**ADDENDUM 3
TO THE CONTRACT PROVISIONS AND CONTRACT PLANS**

**NORTHSHORE UTILITY DISTRICT
CONTRACT NO. C0928 451 CONTROL VALVE FACILITY AND CONTROL
VALVE VAULT**

G&O #18591.00

ISSUED THIS DATE: WEDNESDAY, SEPTEMBER 25, 2024

SHEET C1-4, SCHEDULE A - PROPOSED SITE AND PIPING PLAN

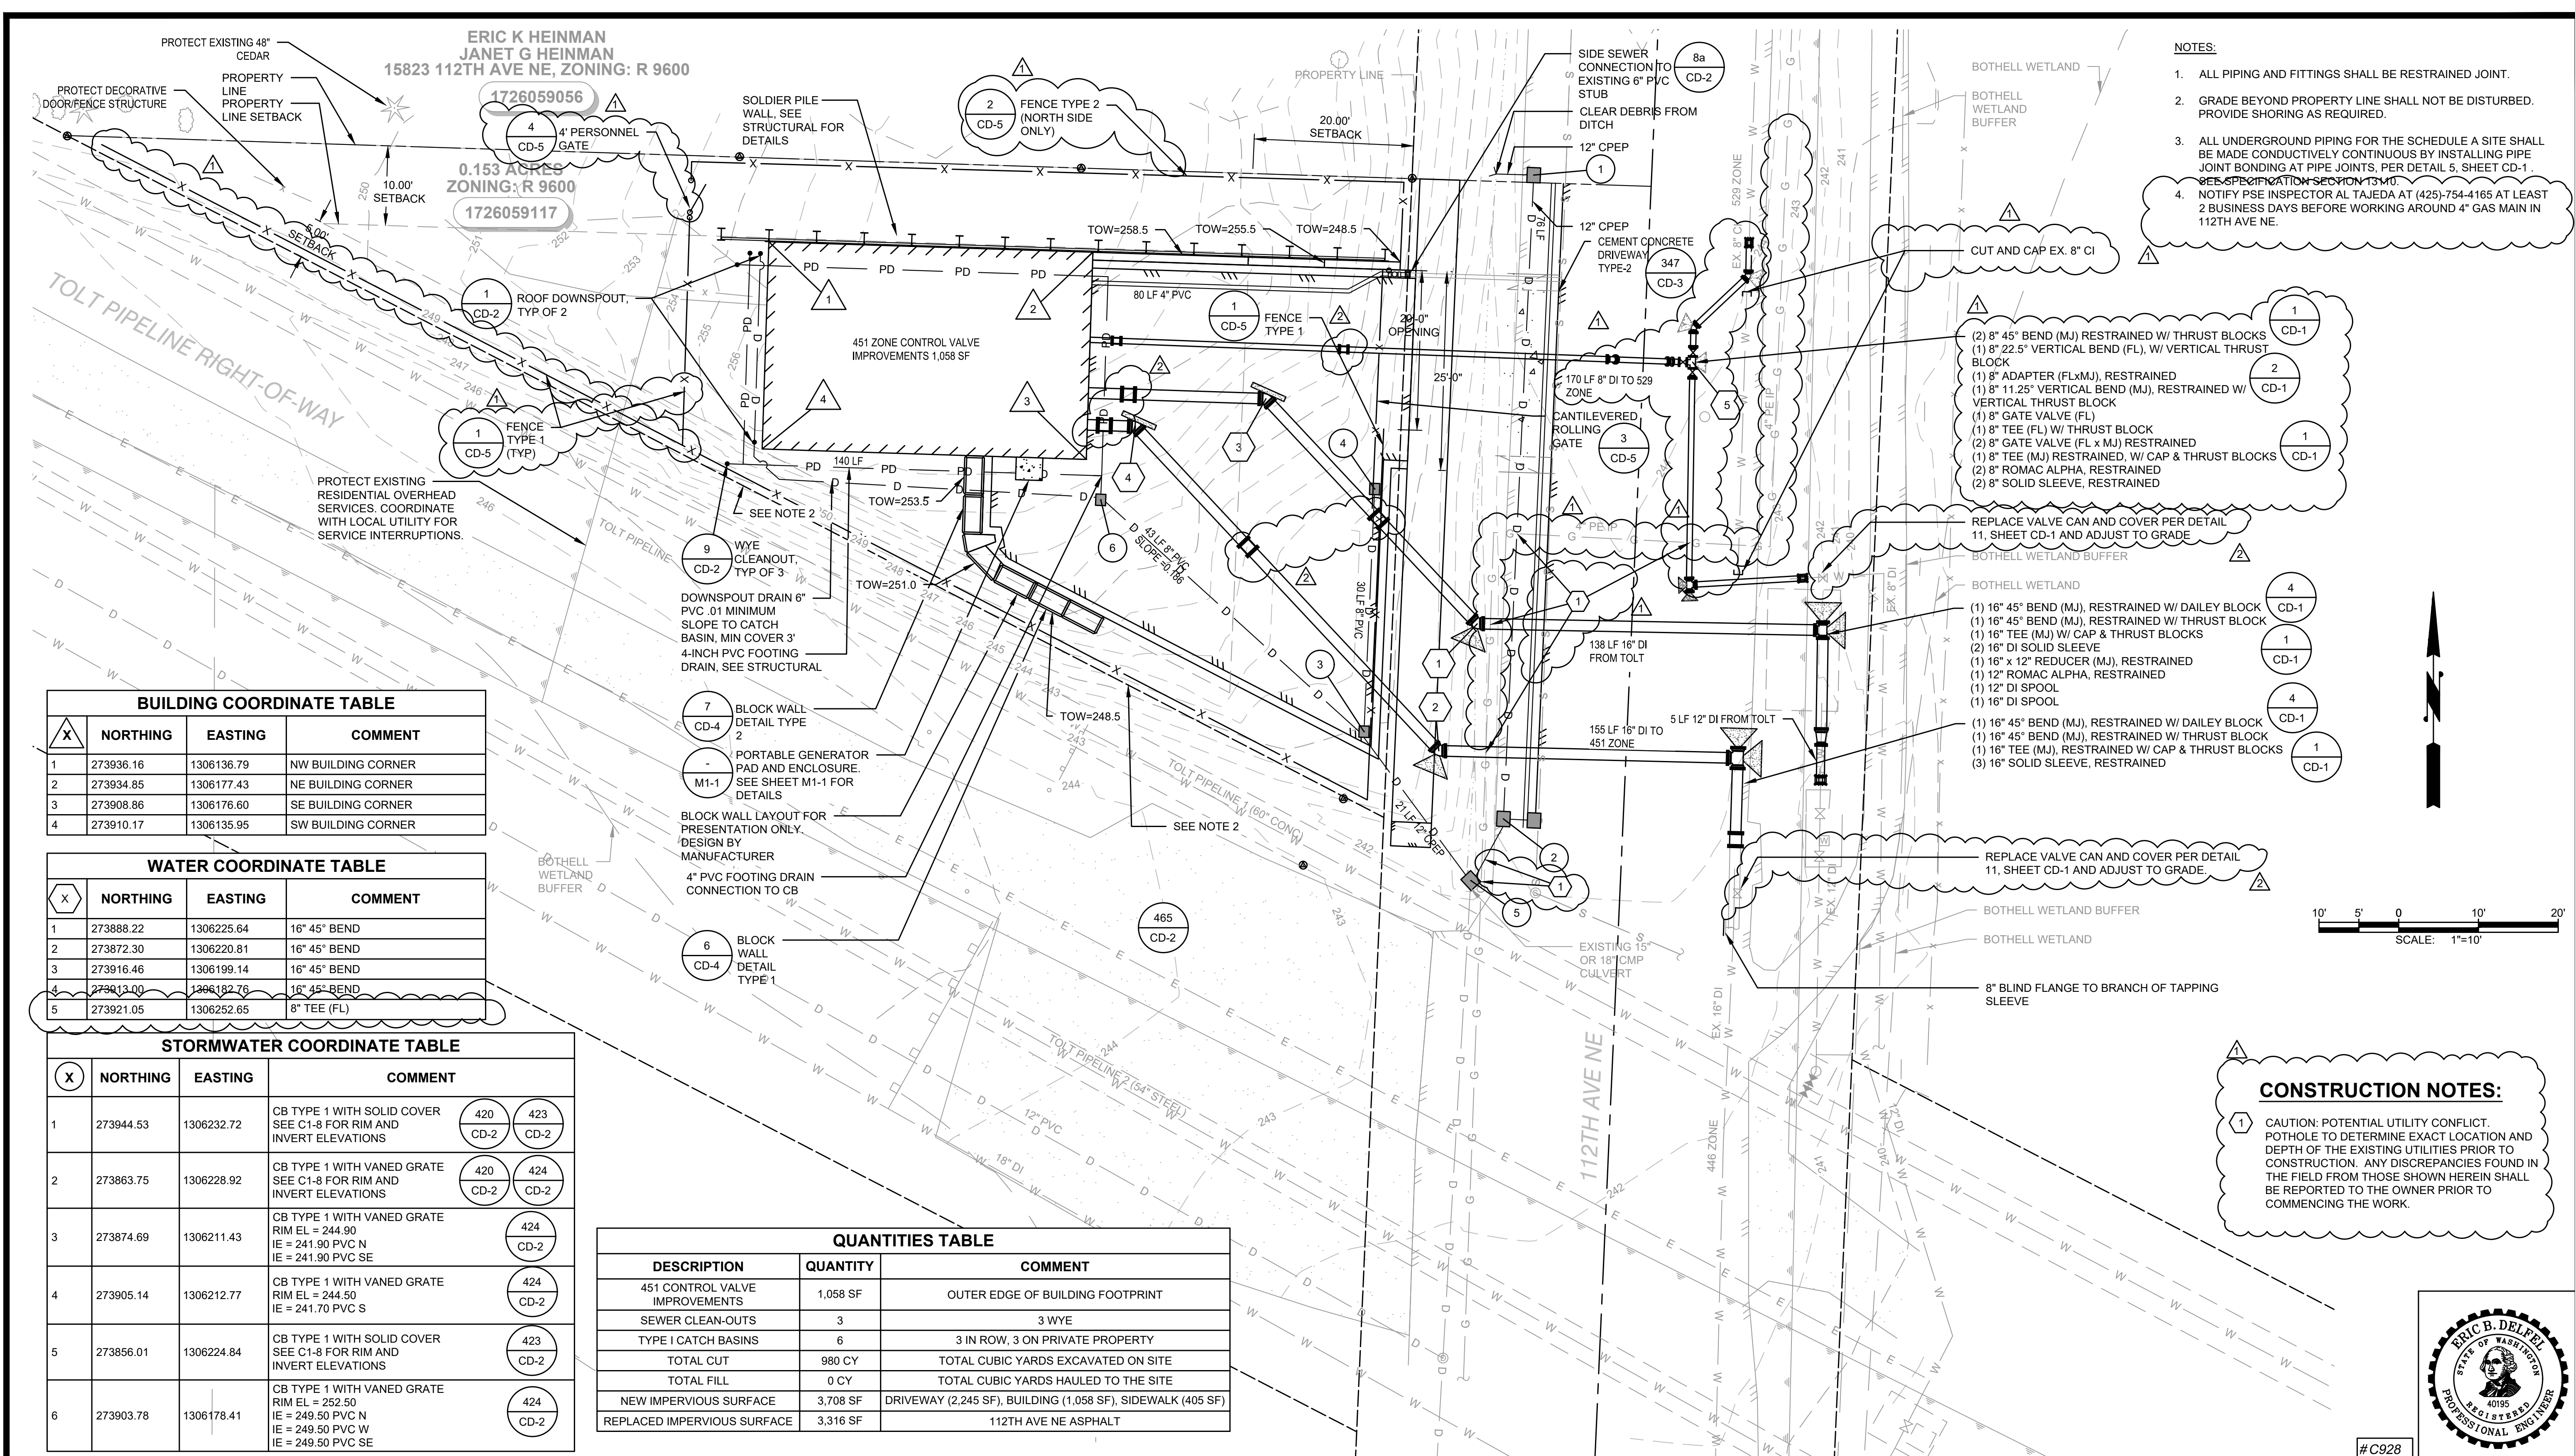
DELETE Sheet C1-4 in its entirety and **REPLACE** with the attached revised Sheet C1-4.

SHEET C1-7, SCHEDULE A - PROPOSED PIPE PROFILES

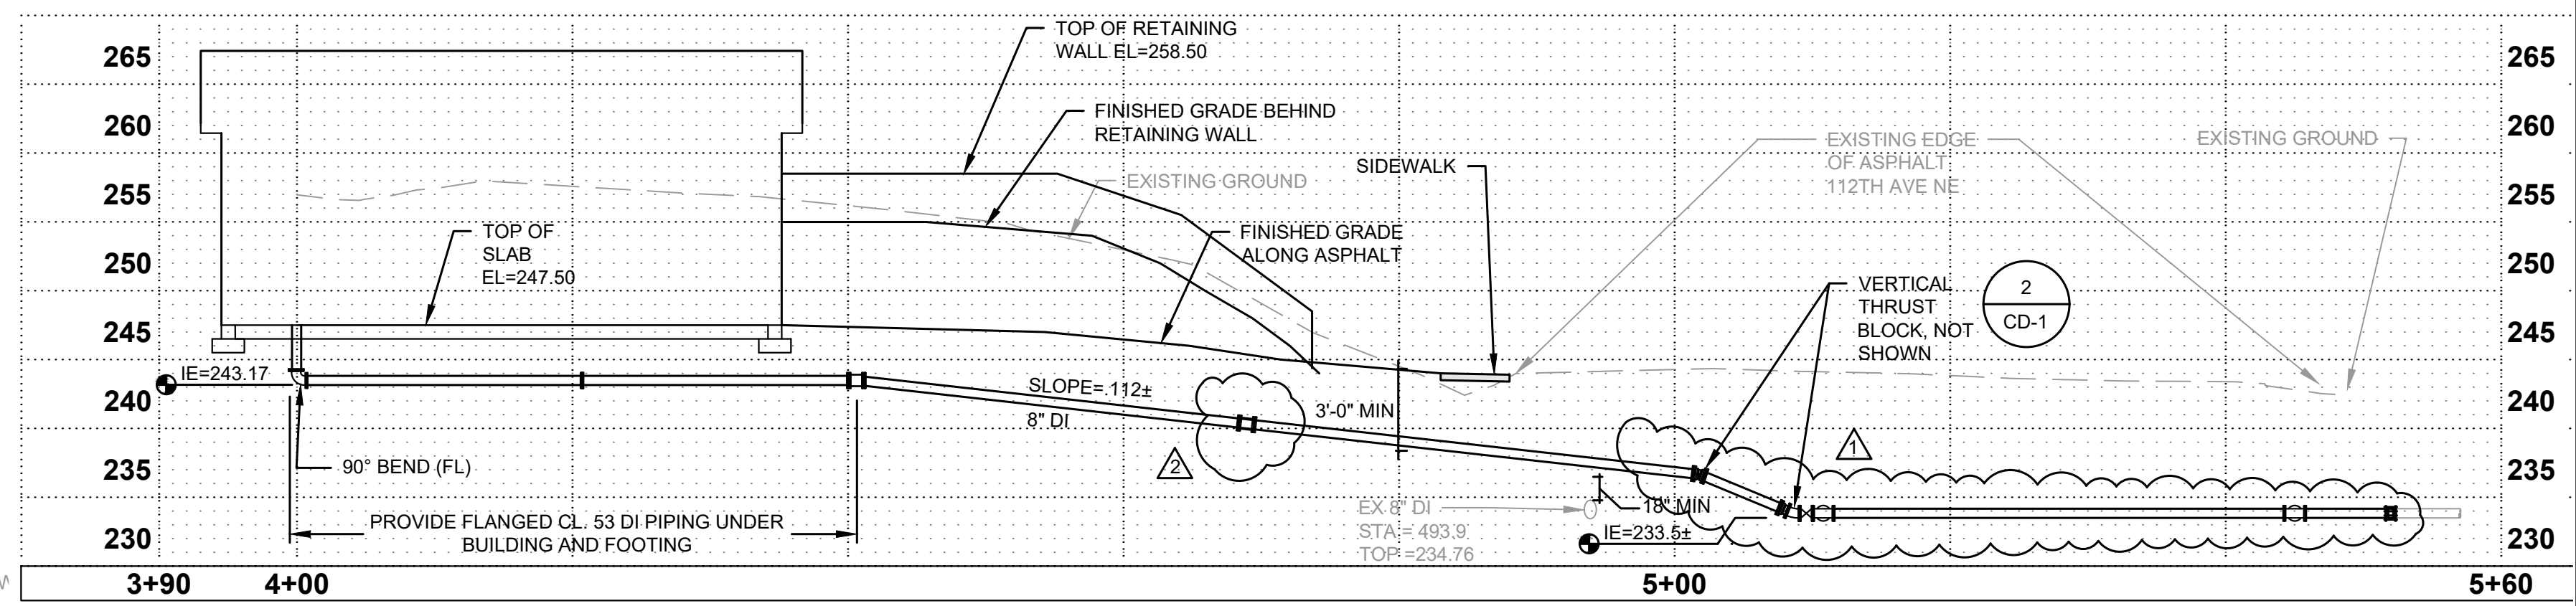
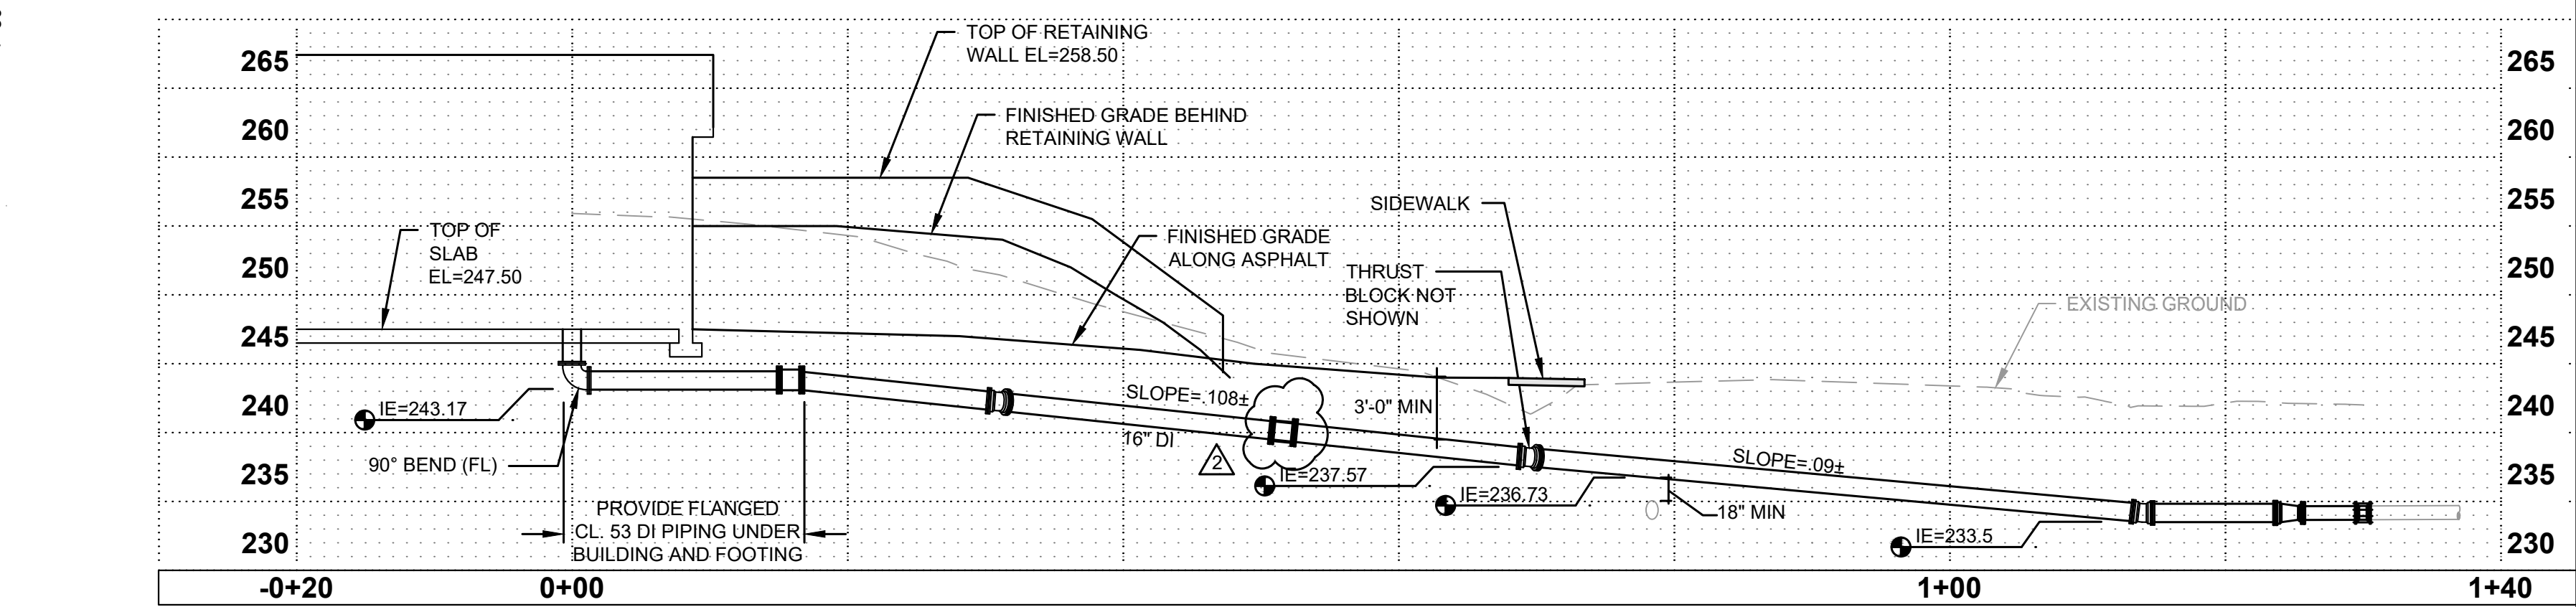
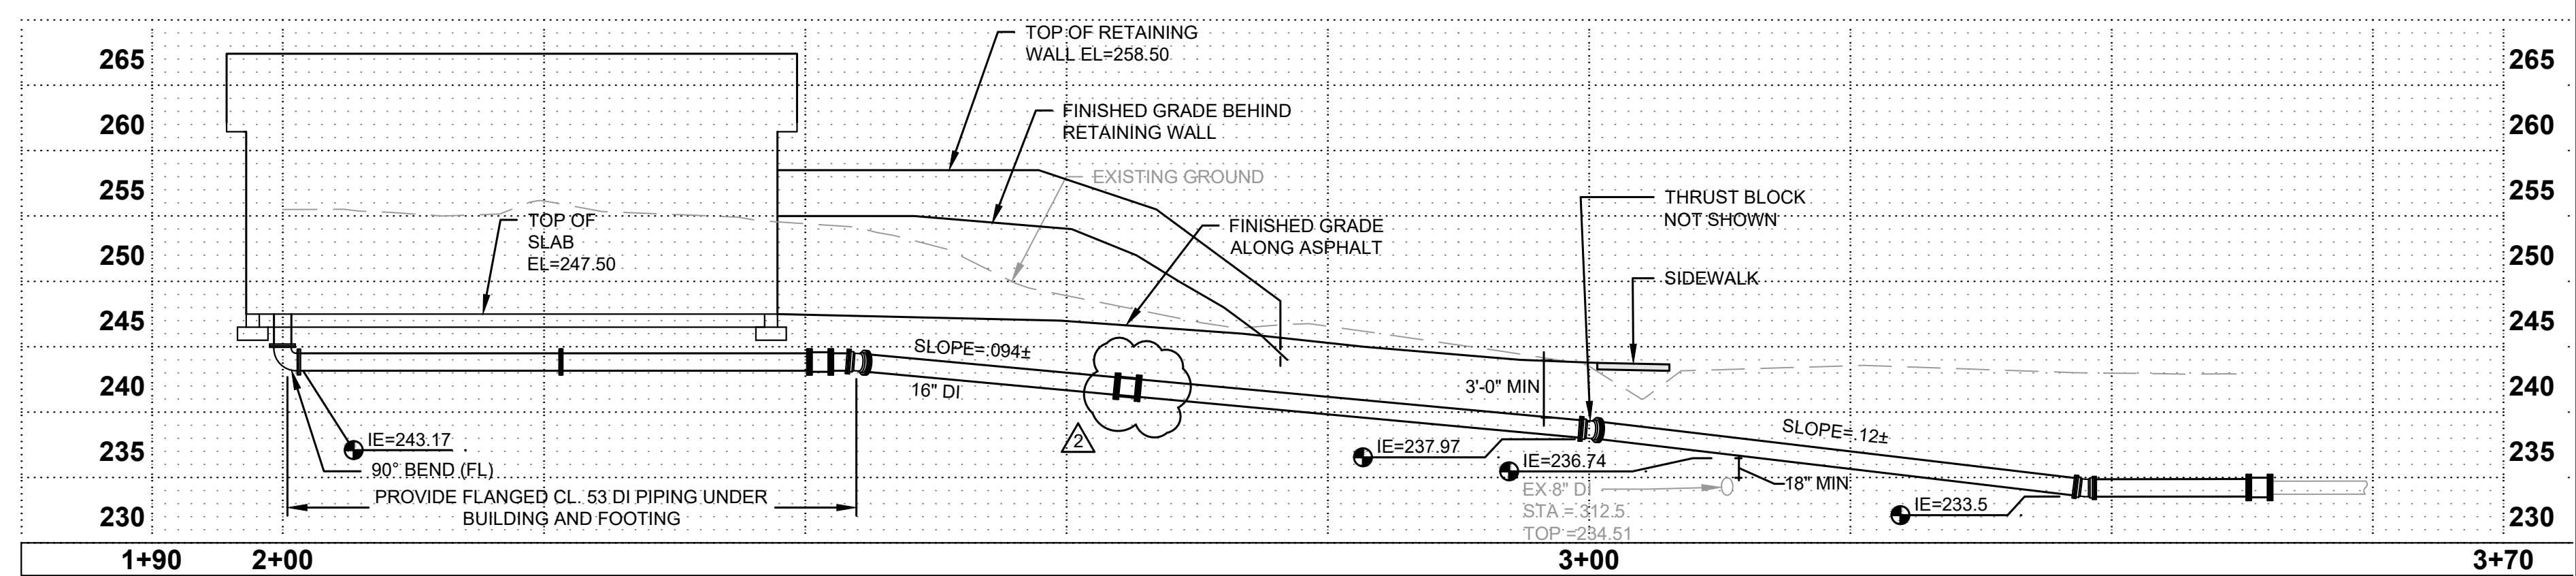
DELETE Sheet C1-7 in its entirety and **REPLACE** with the attached revised Sheet C1-7.
